SERVICE BULLETIN

FUJI HEAVY INDUSTRIES LTD.

NO : FAS-065

1. SUBJECT : Modification of Main Landing Gear Assemblies.
2. AIRCRAFT AFFECTED: FA-200 Series Aircraft, Serial Nos. 2 thru 201.
3. PRIORITY : Essential.
4. REASON : In order to improve safety of the main landing gears.
(An instance was reported where the axle slipped off from the thermal fitted socket.)
5. DESCRIPTION : Check the thermal fitted portion of the axle and socket for looseness, and then install a bolt for security.
6. ACCOMPLISHMENT : One time inspection should be accomplished immediately upon receipt of this Service Bulletin, and modification accomplished no later than the next 50 hour inspection.
7. APPROVAL : JCAB Approval (NO-TOKYO-040) January 24, 1972.
8. PARTS REQUIRED : The following parts will be furnished free of charge to owners of the affected aircraft.

FIGURE 1. MODIFICATION OF MAIN LANDING GEAR

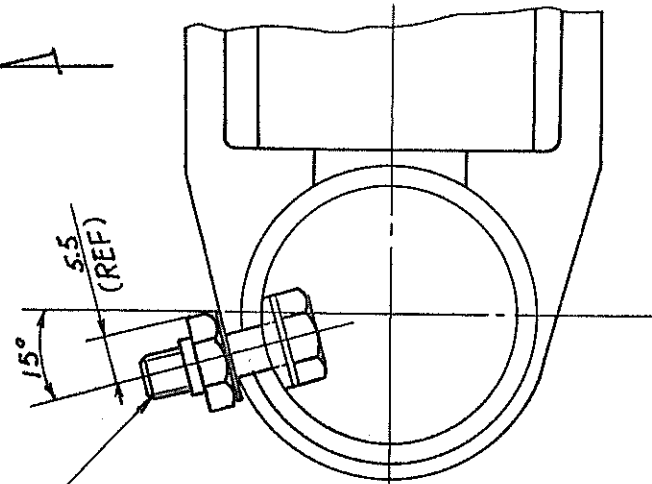
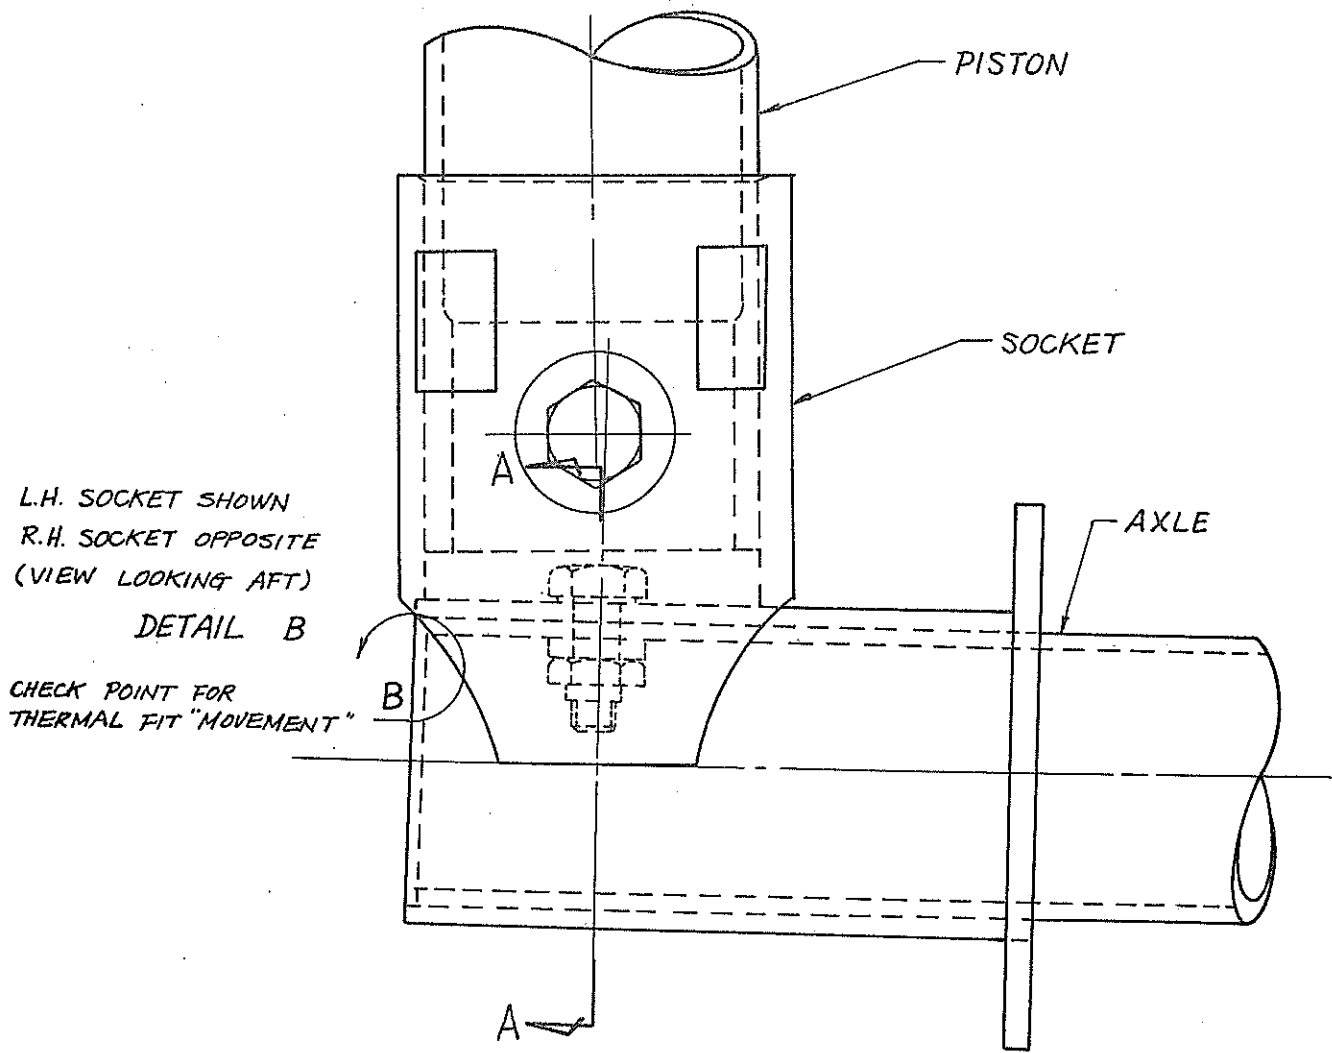
- (1) Clean the end of socket bore, and check for evidence of axial movement of axle. (See figure 1, detail B.)
- (2) If axial movement more than 2 mm is evident in the above inspection, contact Fuji Heavy Industries Ltd. immediately.
- (3) If no movement is found, accomplish modification as follows:

- (1) Jack up main landing gear.
- (2) Drill 0.250 to 0.254 inch diameter hole in socket and axle assy as illustrated in figure 1.
- (3) Remove all burrs, then apply wet zinc chromate primer to hole surfaces.
- (4) Insert AN4-6 bolt into hole with 200-812186-003 special washer. Position special washer against axle inside with radius of washer mated to radius of axle.
- (5) Install AN960-416L washer, and tighten NAS679A4W or MS21042L4 nut.
- (6) Lower main landing gear.

- DRILL : $\frac{254}{250}$ IN DIA
- AN4-6A BOLT 1 REQD
- NAS679A4W OR MS21042L4 NUT 1 REQD
- AN960-416L WASHER 1 REQD
- 200-812186-003 SPECIAL WASHER 1 REQD

FIGURE 2. MODIFICATION OF MAIN LANDING GEAR

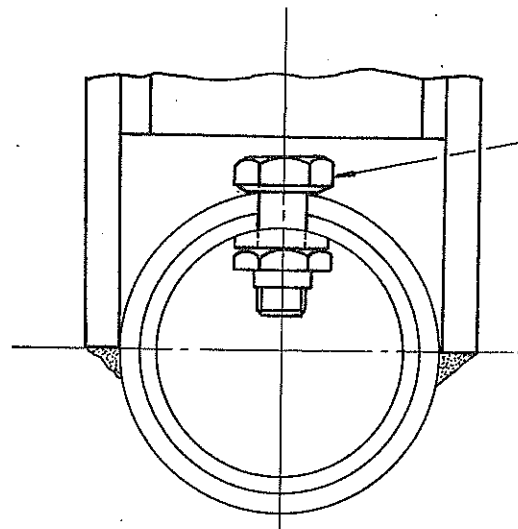
- (1) Clean the end of socket bore, and check for evidence of axial movement of axle. (See figure 2, detail B.)
- (2) If axial movement more than 2 mm is evident in the above inspection, contact Fuji Heavy Industries Ltd. immediately.
- (3) If no movement is found, accomplish modification as follows:

- (1) Jack up airframe and remove tire.
- (2) Remove piston and socket attaching bolt and lower end of torque link, and then remove socket and axle assy.
- (3) Drill 0.250 to 0.254 inch diameter hole in socket and axle assy as illustrated in figure 2.
- (4) Remove all burrs, then apply wet zinc chromate primer to hole surfaces.
- (5) Insert AN4-5A bolt into hole from piston side as illustrated.
- (6) Position 200-812186-003 special washer against axle inside with radius of washer mated to radius of axle, then tighten NAS679A4W or MS21042L4 nut.
- (7) Install socket and axle assy, and connect lower end of torque link, using new cotter pin MS24665-132.
- (8) Install tire and secure with new cotter pin MS24665-360.
- (9) Lower airframe and remove jack.

DRILL .254
IN DIA HOLE THRU
SOCKET AND AXLE.
AN 4-5A BOLT 1REQD
NAS679A4W OR
MS21042L4 NUT 1REQD
200-812186-003 SPECIAL WASHER 1REQD.
